RE: Record # PRSMS20210109 / AT&T Site ID 27107-050-F Application for Small Wireless Facility Permit – Response to February 24, 2022 Comment Memo – First Review

This letter is in response to the City of Puyallup's ("**City**")'s February 24, 2022 Comment Memo regarding New Cingular Wireless PCS, LLC ("**AT&T**")'s application for a Small Wireless Facility Permit to locate small wireless facilities ("SWF") on City of Puyallup Public Works owned street light poles, AT&T site identification number 27107-050-F.

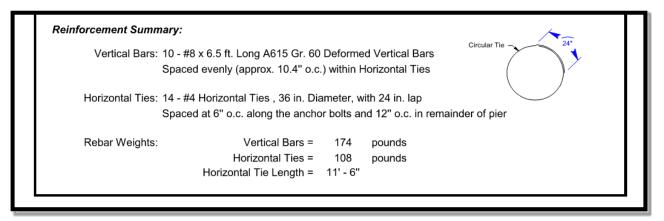
- Handhole is to be placed on the South face of the pole per CS 01.05.01(1) [WATCM-050-F; Sht 11]
 - Revision incorporated into Civil Plans
- Verify-25" dia BC used in Calcs [WATCM-050-F; Sht 15]

• Confirmed; Structural Calcs will be included in resubmittal package for reference. Pg 12

Anchor Bolt & Base F	late D	ata:			
No. of Anchor Bolts, n =	4		Yield Strength, Fy_AB =	55.0	ksi	A.B. Gross Area, A _g =	1.77	ir
AB Diameter, D _{AB} =	1.50	in.	Tensile Strength, F _{u_AB} =	75.0	ksi	A.B. Tensile Stress Area, A _n =	1.41	ir
AB Circle, D _{BC} =	25.0	in.	Base Plate Width, W _{BP} =	23.0	in.	A.B. Plastic Modulus, Zar =	0.47	ir
AB Length, LAB =	72.0	in.	Pole Diameter, D _{pole} =	20.00	in.	Dist. Btwn Concr. & Lvl'g Nut, I _{ar} =	1.50	ir
